ADDENDA AND MODIFICATIONS

ADDENDUM NUMBER: 1 **DATE:** July 21, 2005

PROJECT: WORKFORCE SERVICES
DFCM PROJECT NO. 04045920
Architect Project No. 04139

ISSUED BY: ARCHITECTURAL NEXUS, INC.
Bruce Haslem, Architect

ADD1

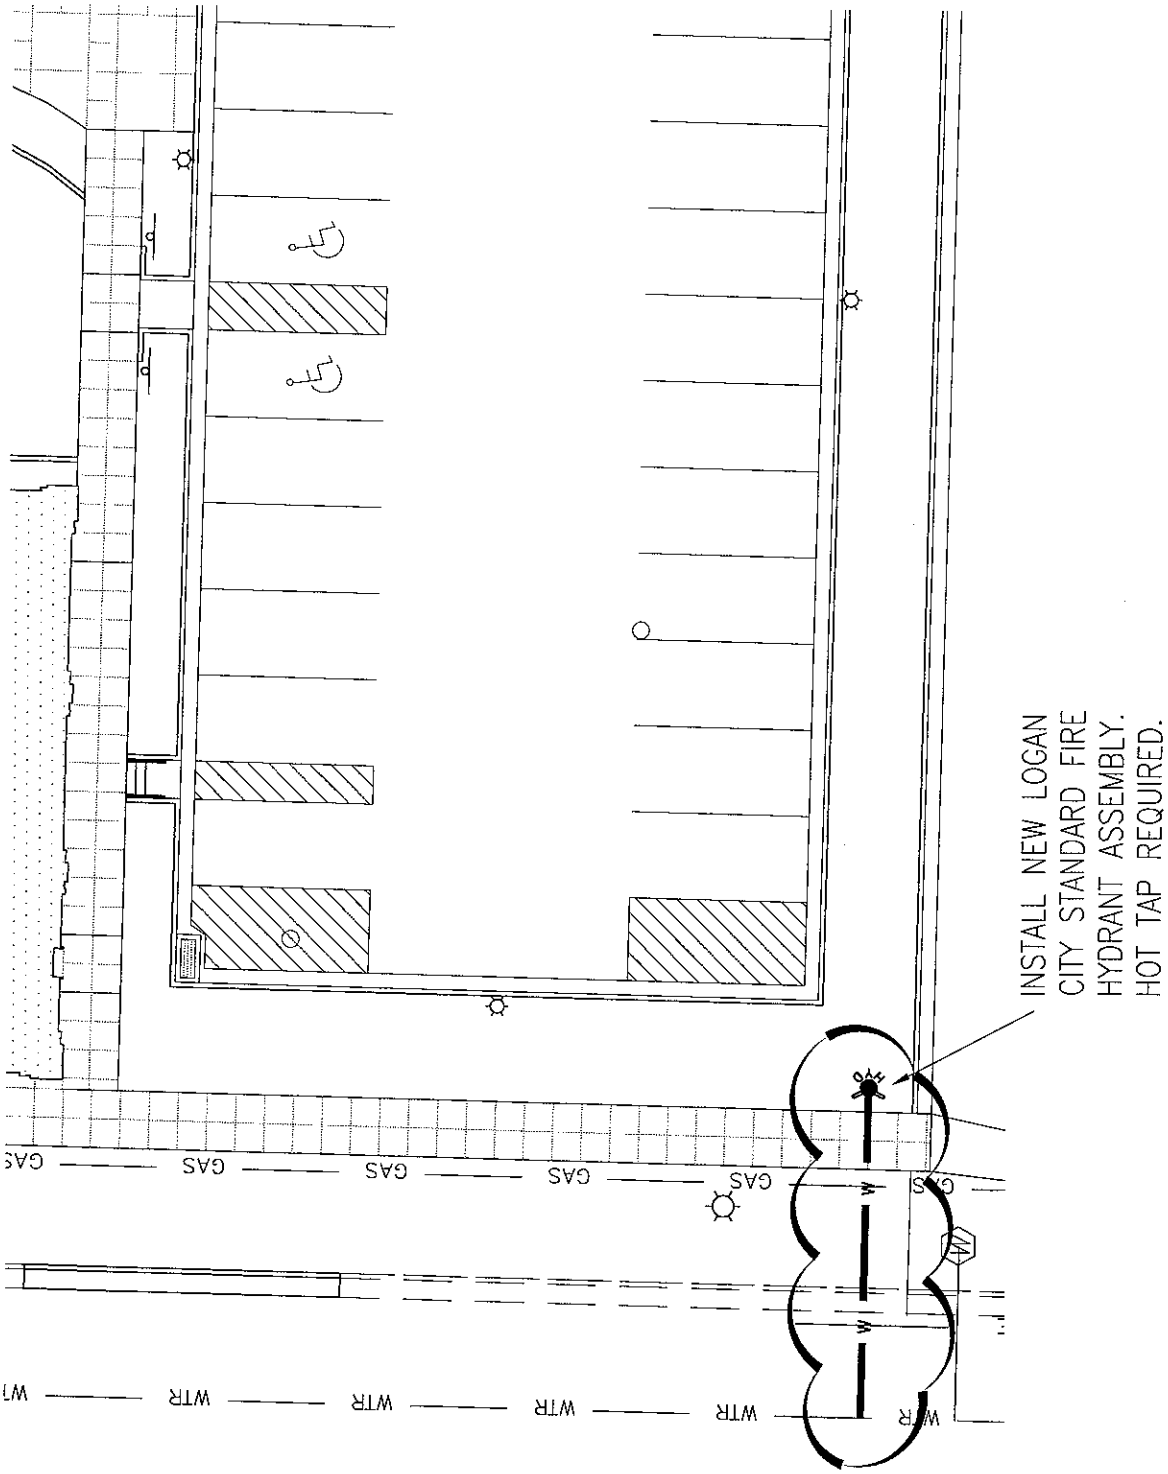
Item 5. Drawing AS103
Add a new fire hydrant per attached drawing ADD1.

ADD2

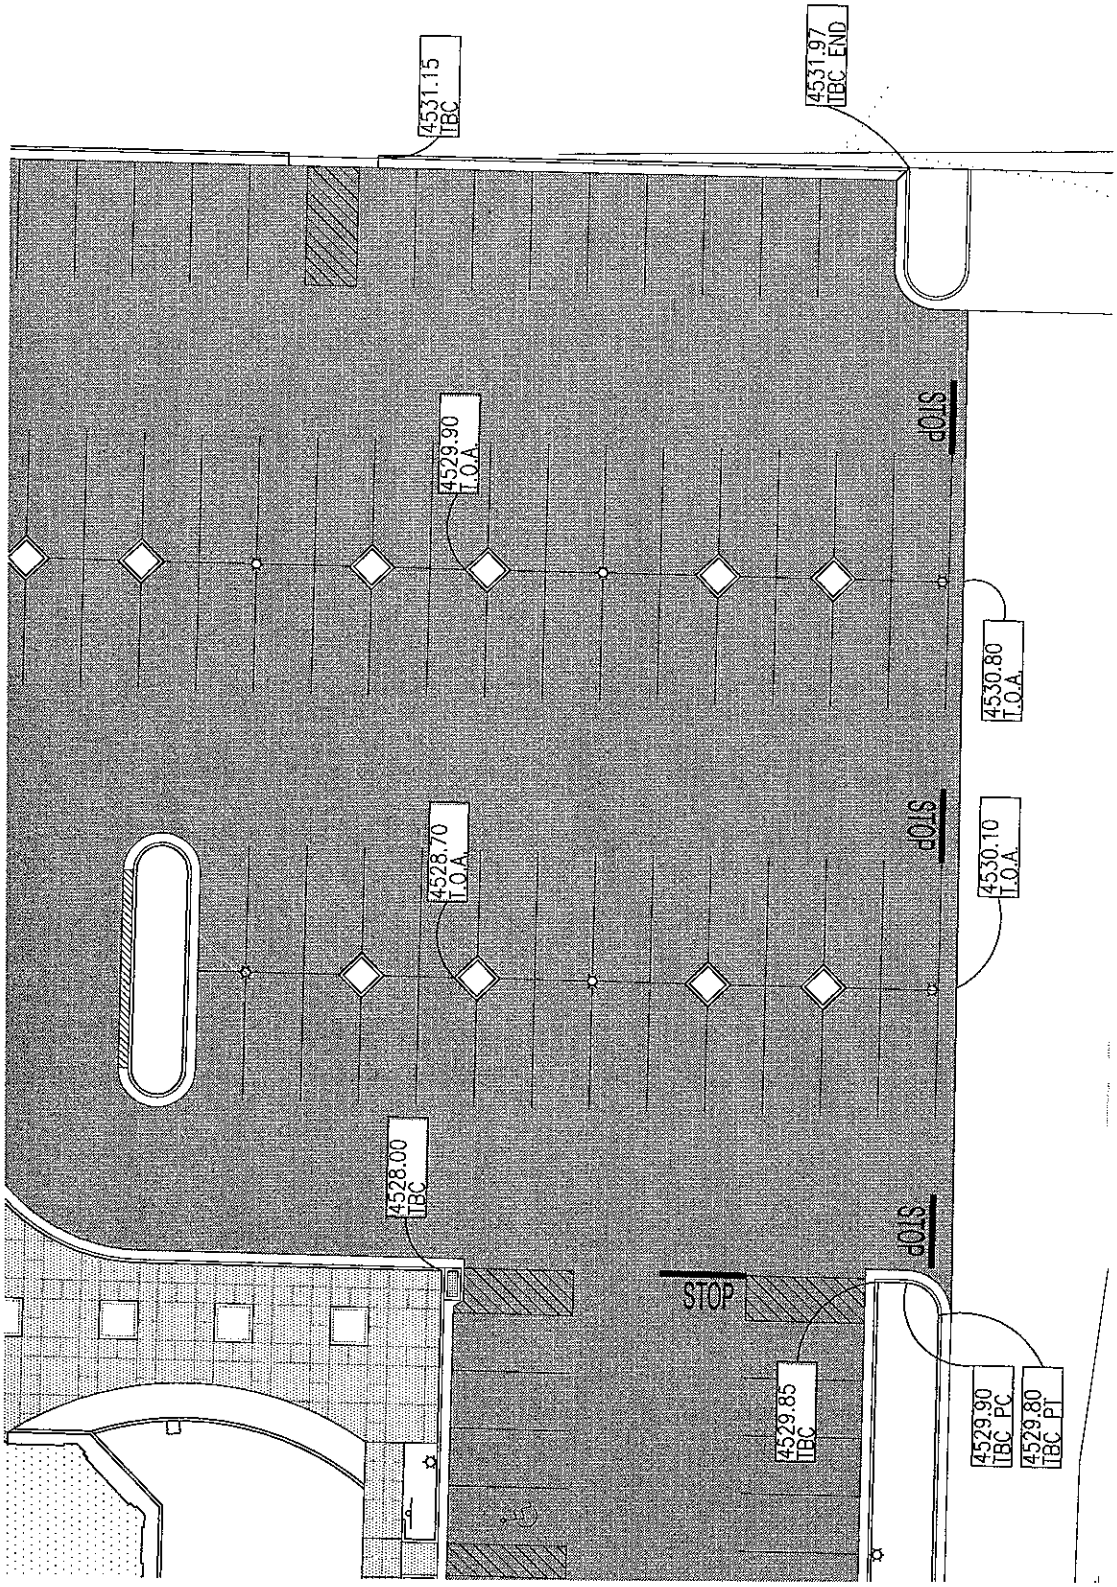
Item 4. Drawing AS101
Per attached drawing ADD2, revise grades as shown.

REVISE GRADES AS SHOWN.

13 ANGLE @ PERIMETER OF DECK

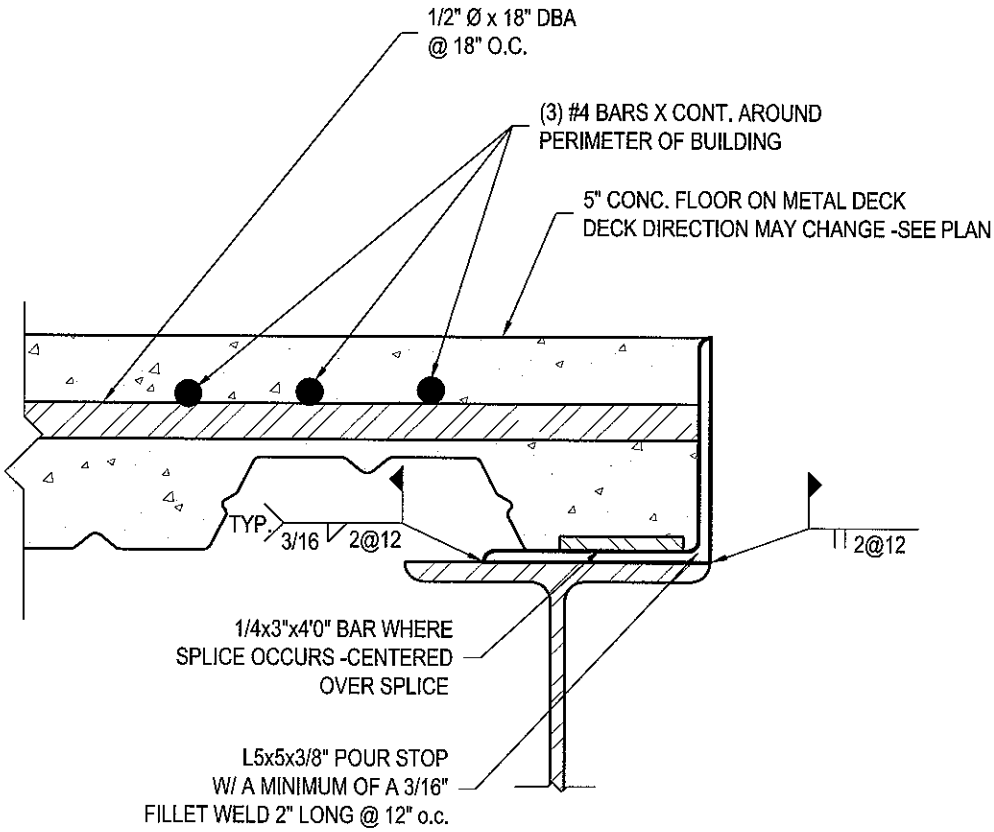
43. Details 3 & 6, add detail reference at edge of slab *13/S501 SIM.*
44. Detail 4, omit note *SCREW AT EA. JOIST T&B.*
45. Replace detail 13 with attached detail.
46. Detail 14, note specifying blocking between joists, change detail reference from 8/S404 to 1/501.
47. Replace detail 15 with attached detail.

15 **DETAIL**
SCALE: 1"=1'-0"
SHEET S501

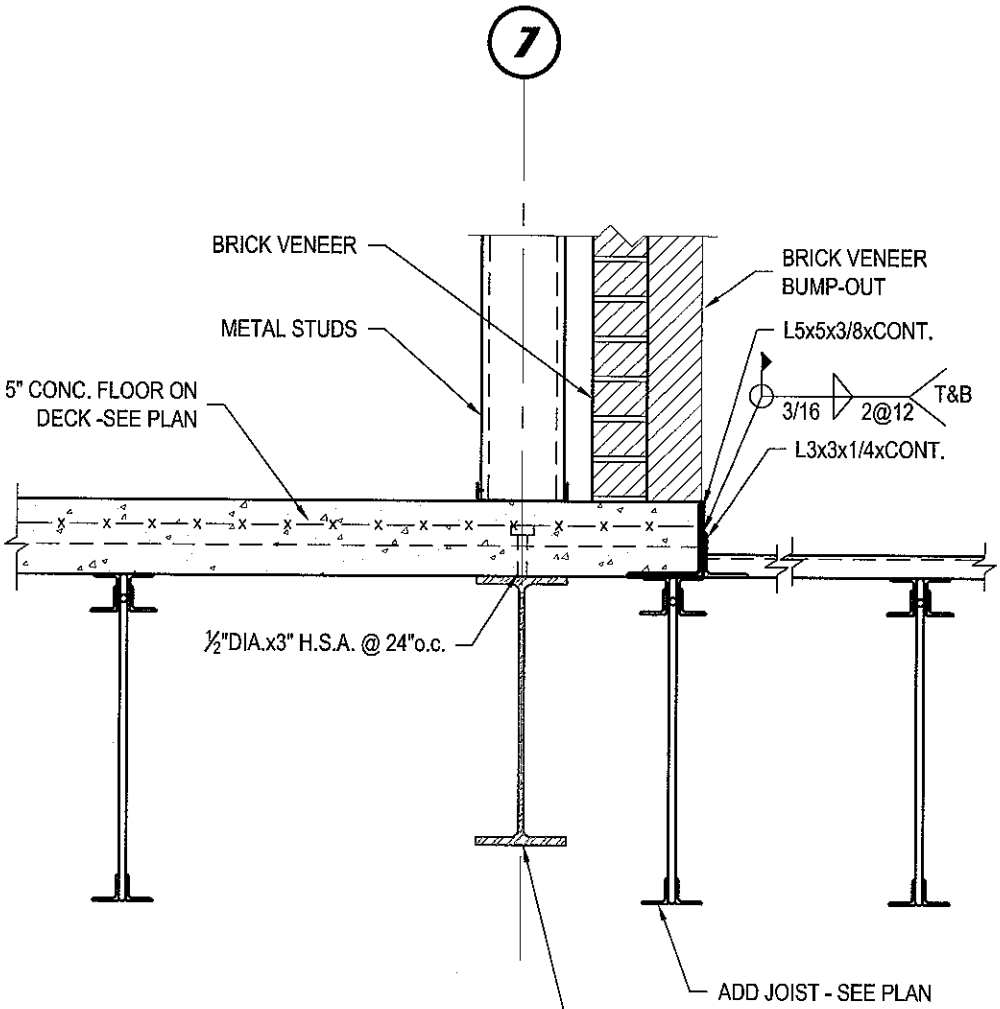
22. All top of steel callouts are to be above elevation 100'-0".
23. Add keynote 11 as follows, *Provide headed stud anchors (HAS's) on beams along grid 7, see detail 15/S501* (revised detail is attached).

3 CANOPY JOIST CONNECTION DETAIL

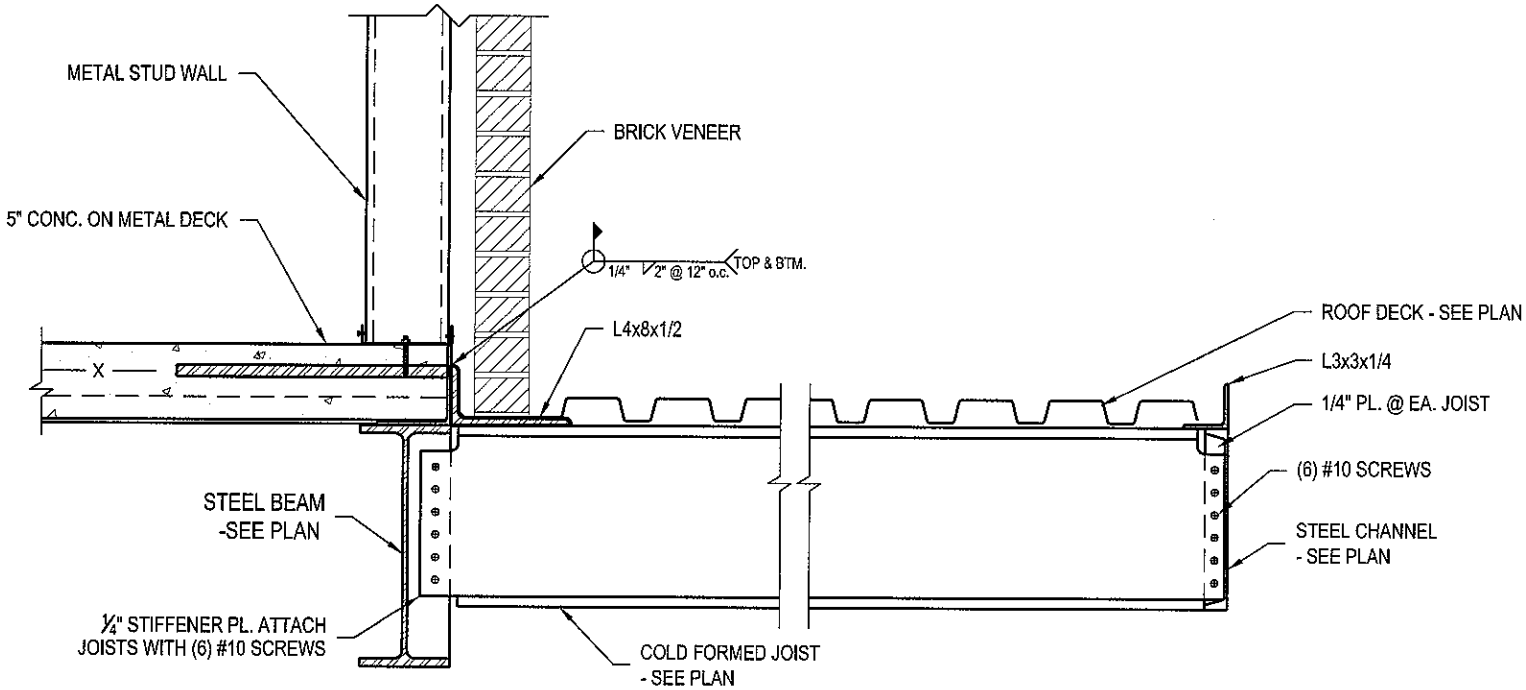
49. Detail 2, change detail title to *Joist Support Detail.*
50. Replace detail 3 with attached detail.
51. Add details 4 & 5 with attached details.

4 TYP. BEAM / BEAM CONN.

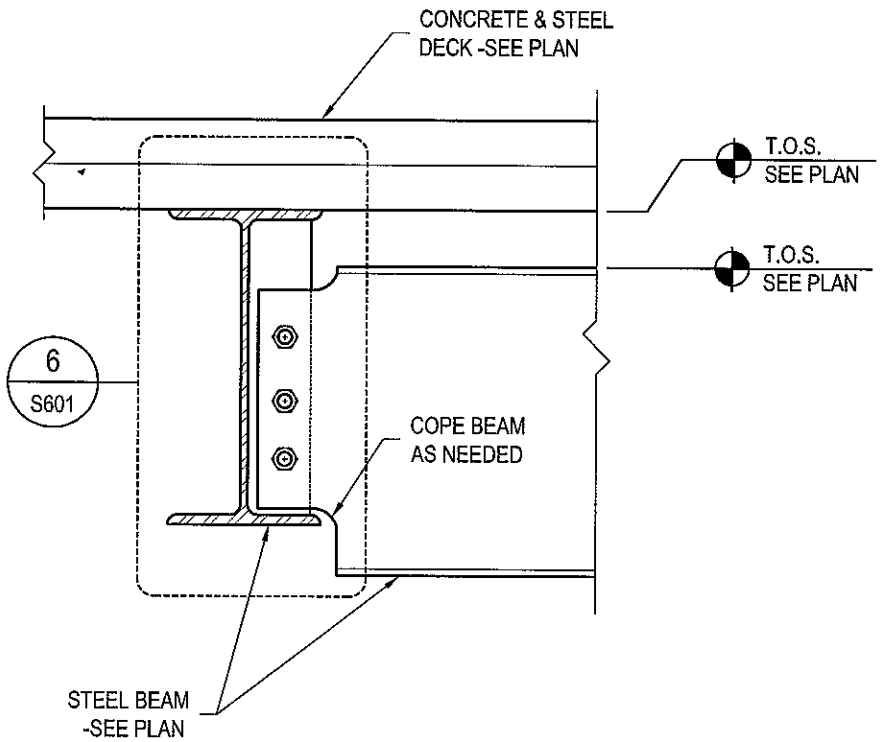
27. Change detail callout along grid B & 2.6 and along grid A & 4.9 from 6/S501 to 4/S501.
28. Change detail callout along grid 7 & B.1 from 8/S501 to 4/S503 OPP. (detail is attached).

29. Change detail callout along grid 6.6 & D.7 from 8/S501 to 4/S503 (detail is attached).
30. In floor & roof framing notes, note #7 change SW3 to SW4.

5 TYP. COL./ JOIST / BEAM CONN.

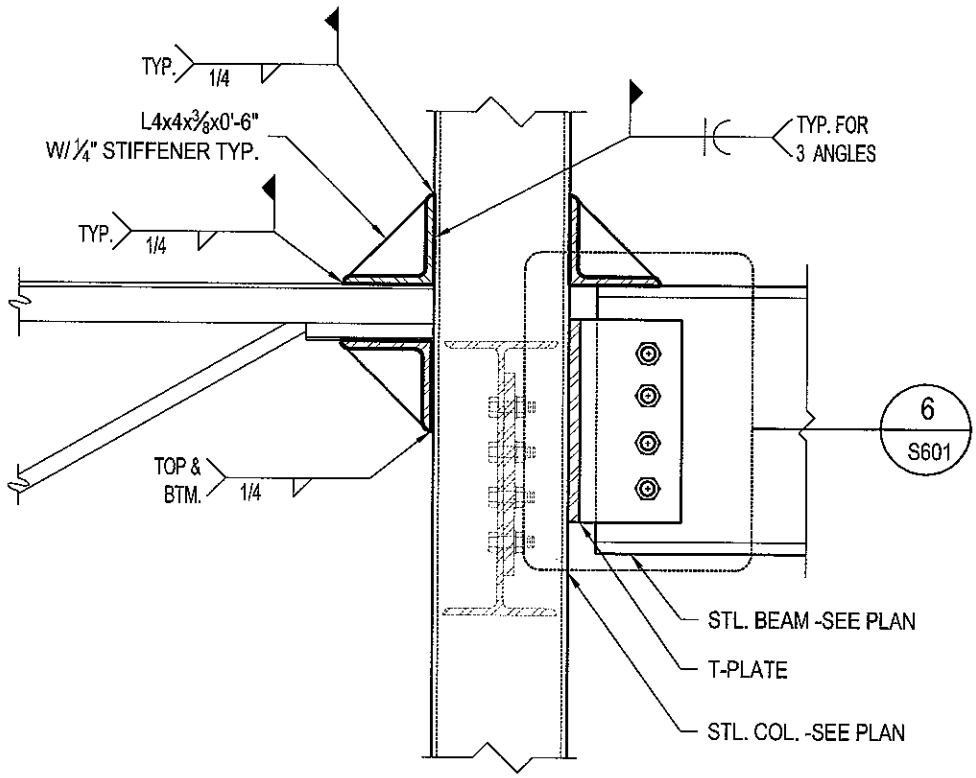
24. Change keynote at grids 4 & B from 3 to 12. Add keynote 12 as follows, *Provide angles above joists/beams as per detail 5/S503* (detail is attached).

25. Change detail callout at grids 4 & B from 10/S501 to 5/S503 (detail is attached).
26. Where 2-story wall section occurs use the following details; detail 1/S502 where steel floor joists are perpendicular to wall, detail 2/S502 where steel floor joists are parallel to wall, and details 3&12/S502 where brick veneer bump outs occur.

M101

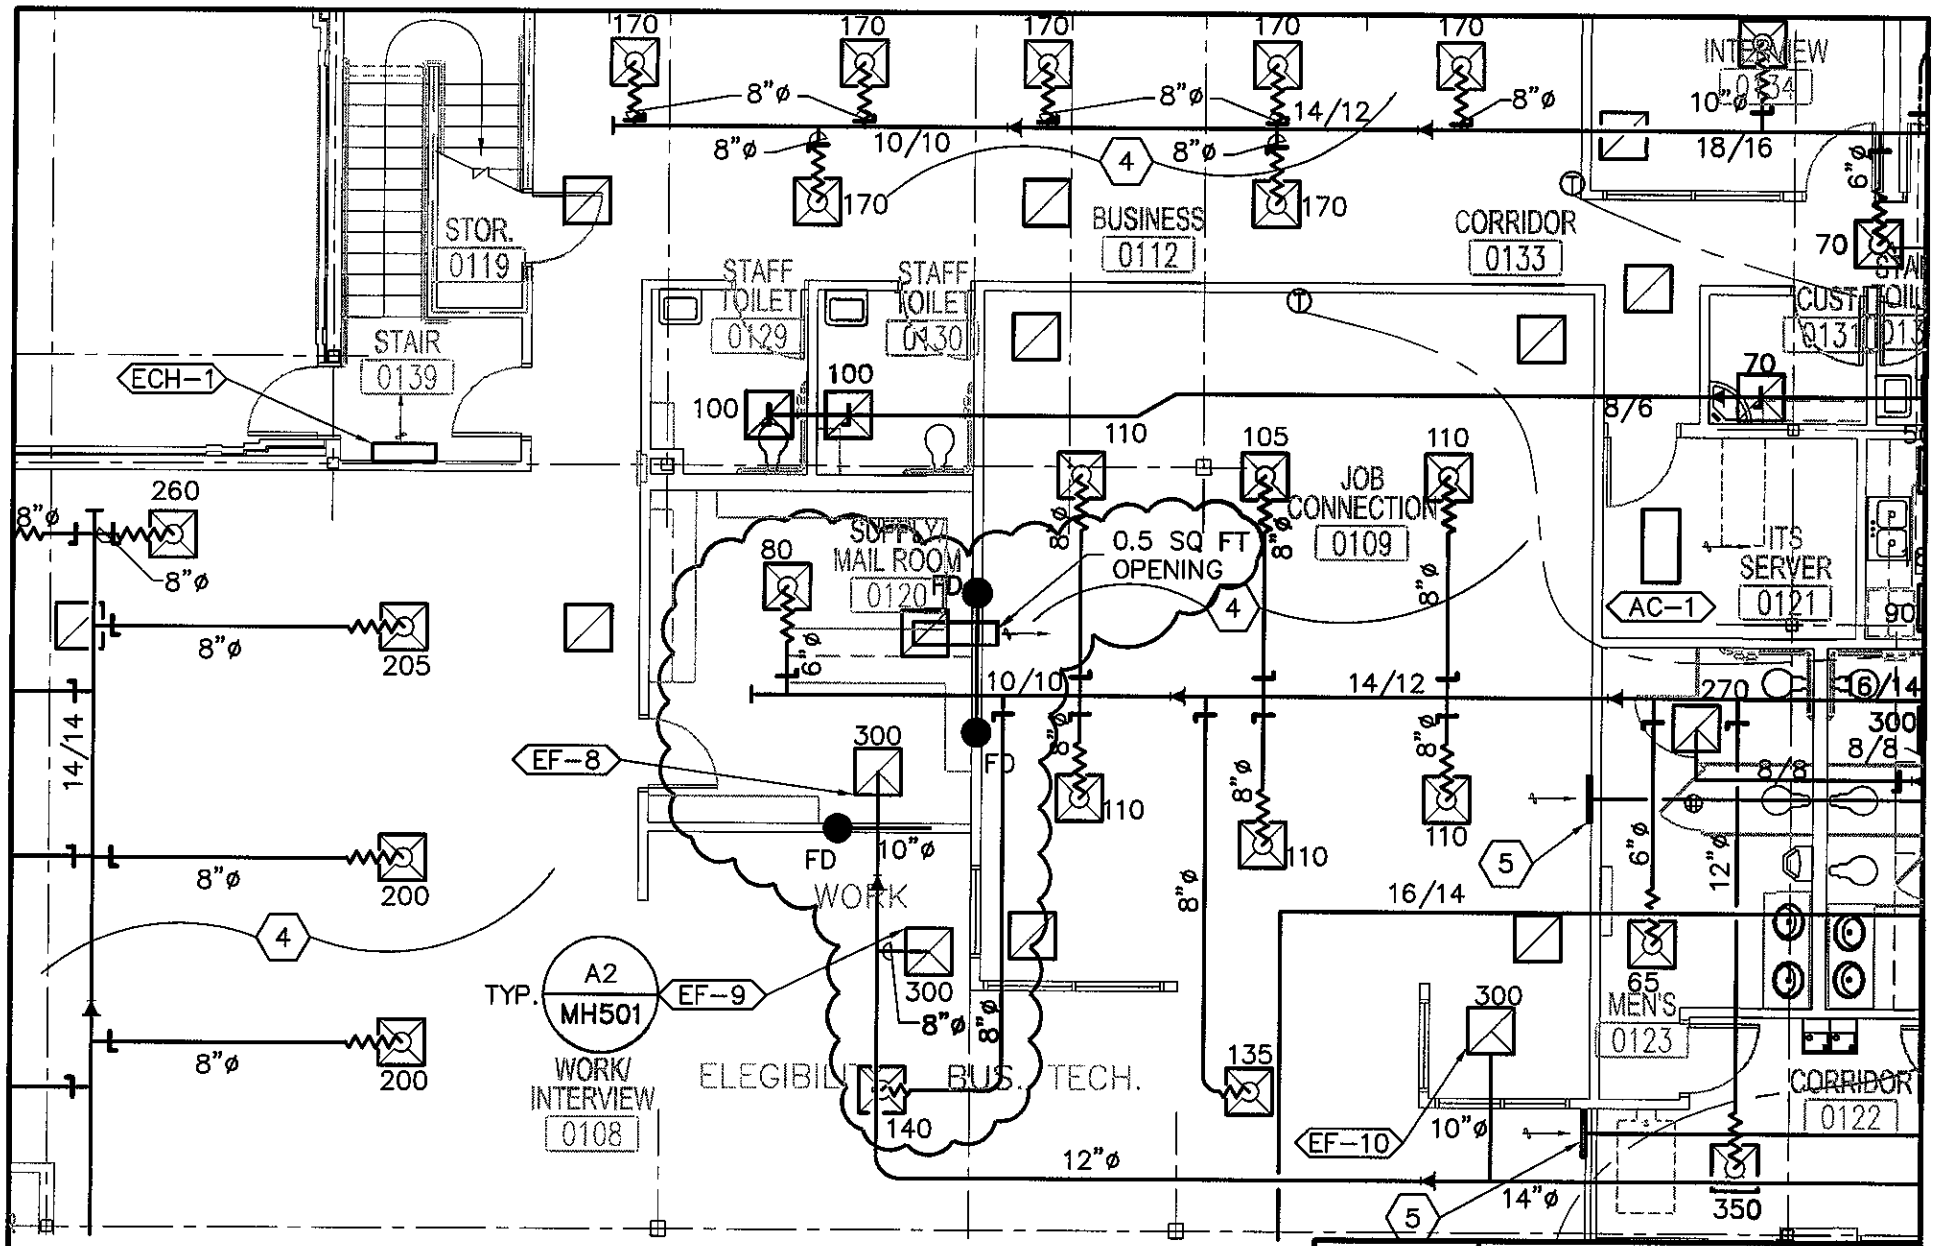
1. Add fire dampers and return air duct to room 120. Re-rout supply ductwork as shown. See attached 1/MH101.
